GOVERNMENT/INDUSTRY AERONAUTICAL CHARTING FORUM
Instrument Procedures Group
May 1, 2007
HISTORY RECORD

FAA Control # 07-01-274

Subject: AIM Information Regarding ODP Minimum Crossing Altitudes

Subject: Minimum Obstruction Clearance Altitudes Depicted on Standard Instrument Departures (SIDs)

ZEFFR THREE DEPARTURE (RNAV)

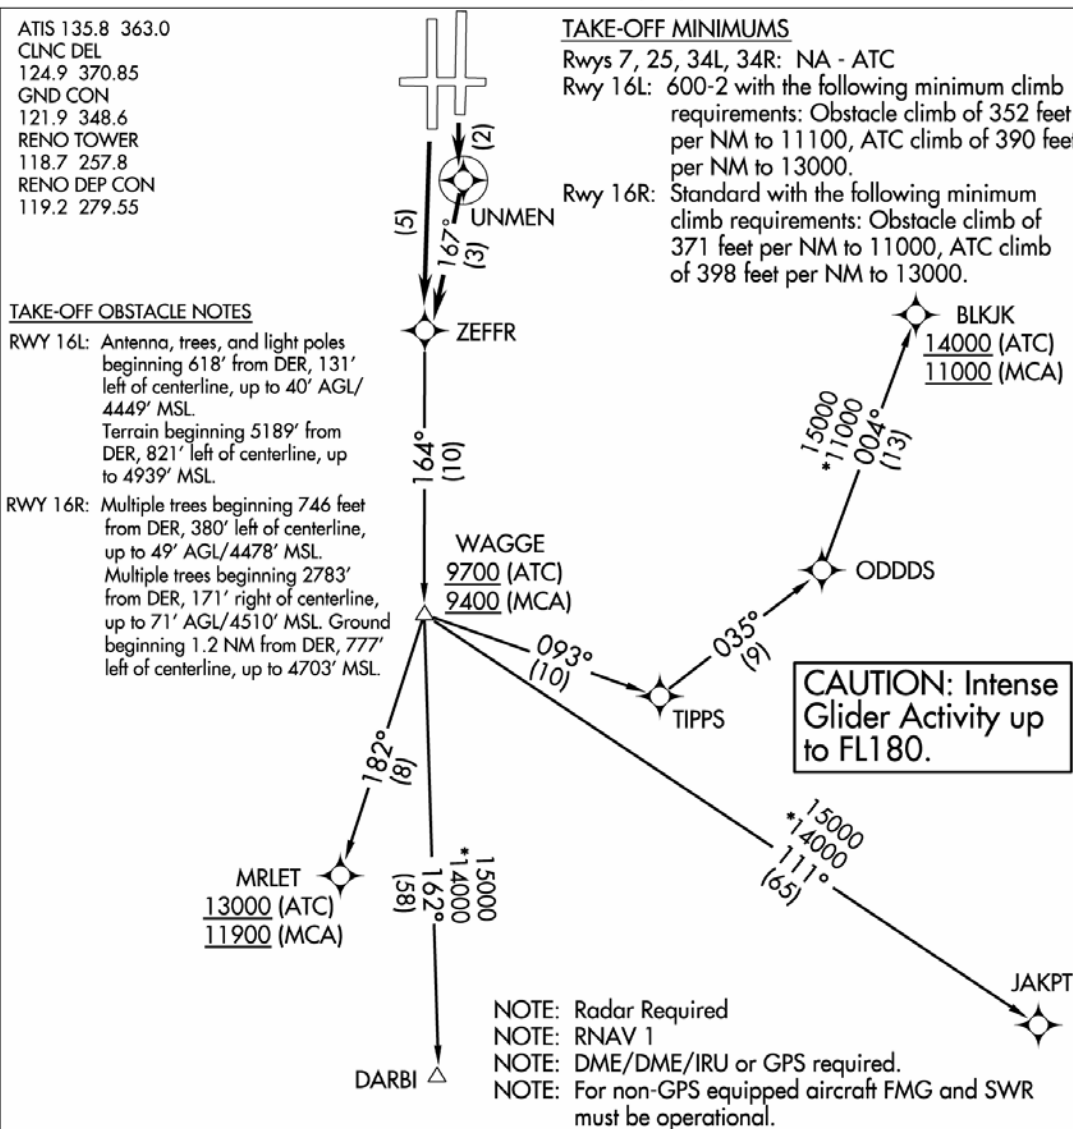
Background/Discussion: FAA Order 8260.46C, Departure Procedure Program, paragraph 10(f)(1), Charting Minimum Altitudes, requires that SIDs (both conventional and RNAV) must depict minimum altitudes for obstruction clearance; and, where appropriate, any required minimum ATC altitudes. Where these differ, documentation of both minimum altitudes is required on the 8260-15 form. Appendix 5 (Non-RNAV DP's) and Appendix 6 (RNAV DP's) of this Order require that SIDs accommodate ATC and obstruction clearance requirements by documenting the ATC altitude followed by the altitude required for obstruction clearance. Charting agencies must depict the obstruction altitude as a minimum crossing altitude (MCA). An example of the application of this requirement may be seen on the attached ZEPHR THREE RNAV SID at Reno, NV (RNO).

EDETH ONE DEPARTURE (RNAV)

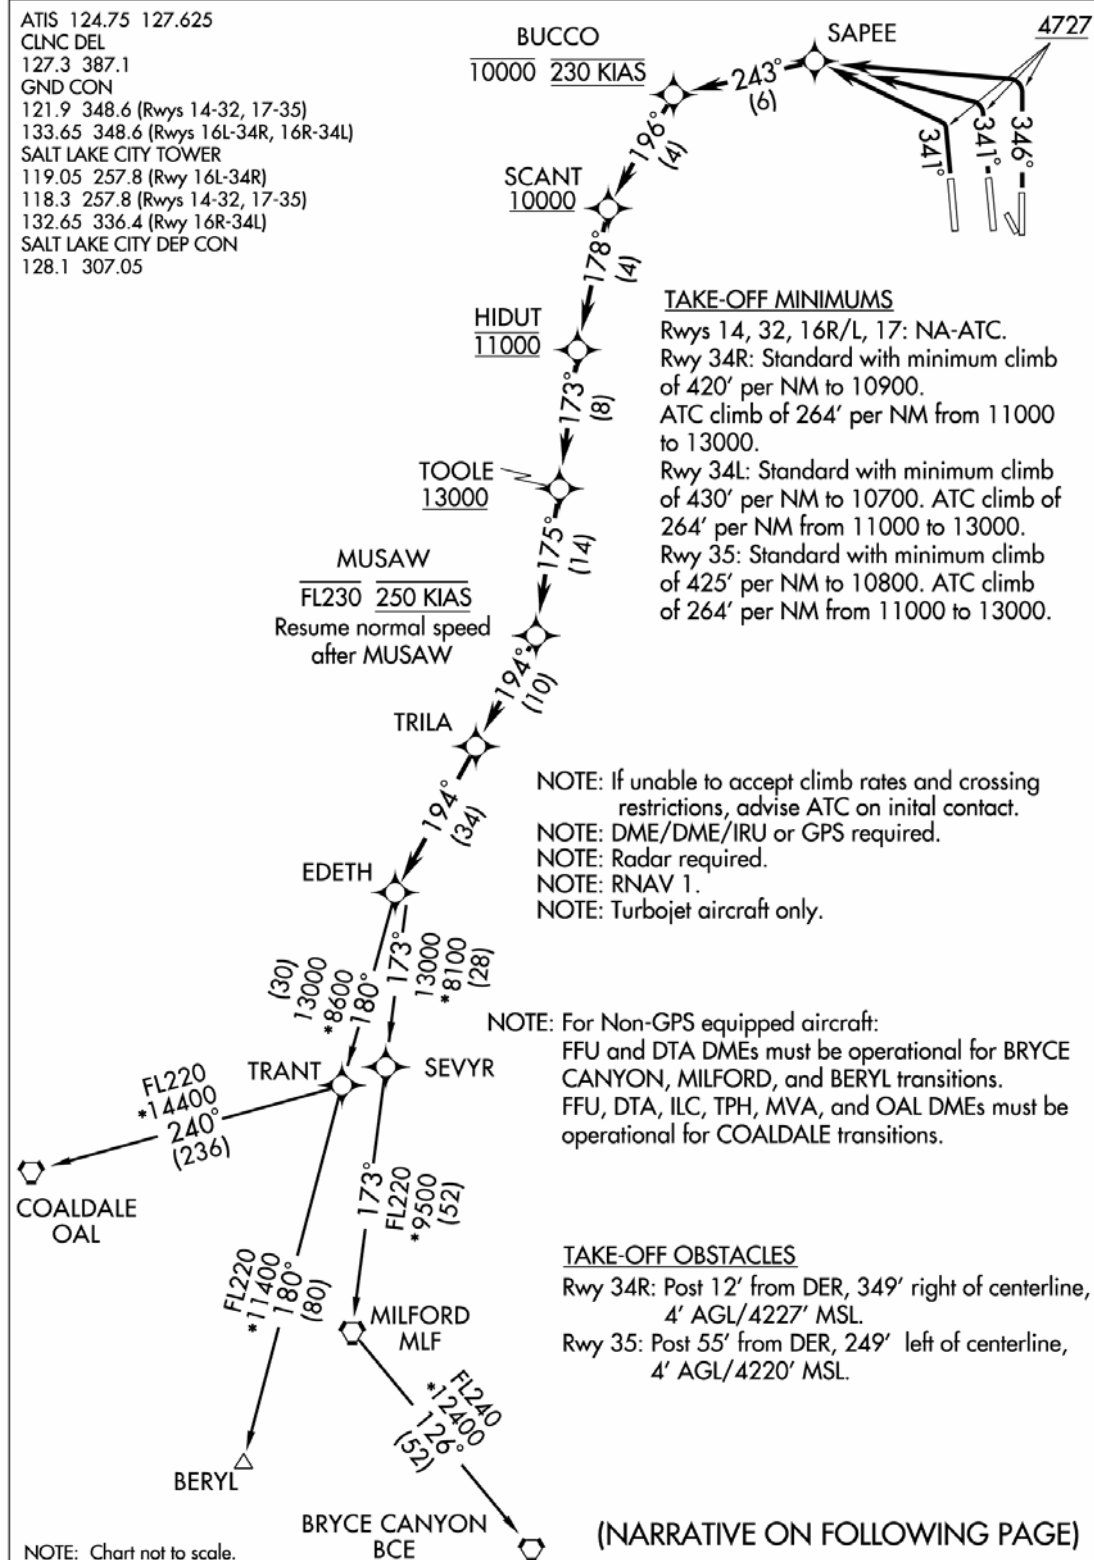
Some recently published Graphic DP's fail to depict minimum obstruction clearance altitudes in accordance with the above stated requirements. Two examples of SIDs that do not comply are the EDETH ONE (RNAV) at Salt Lake City, UT (SLC) and the GABRE SIX at Los Angeles, CA (LAX), both of which are attached. Further, there are several other Graphic DPs currently in coordination that also fail to depict the minimum altitudes for obstruction clearance.

All Graphic DP's should be designed and charted in accordance with the criteria contained in FAA Order 8260.46C with respect to fix minimum altitudes for obstruction clearance (MCA) and for air traffic purposes (ATC). Further, the future revision to the 8260.46 Graphic DP's should require the charting of the applicable MOCA for all non-vector procedure legs.

An immediate review of all Graphic DP's published since the issuance of the "C" revision to the 8260.46 Order should be initiated to ensure that minimum crossing altitudes for obstruction clearance are properly charted. Priority should be given to SIDs established at airports located in designated mountainous terrain as specified in 14 CFR 95, Subpart B. Further, all Graphic DP's currently in coordination should also be reviewed for compliance with 8260.46C.
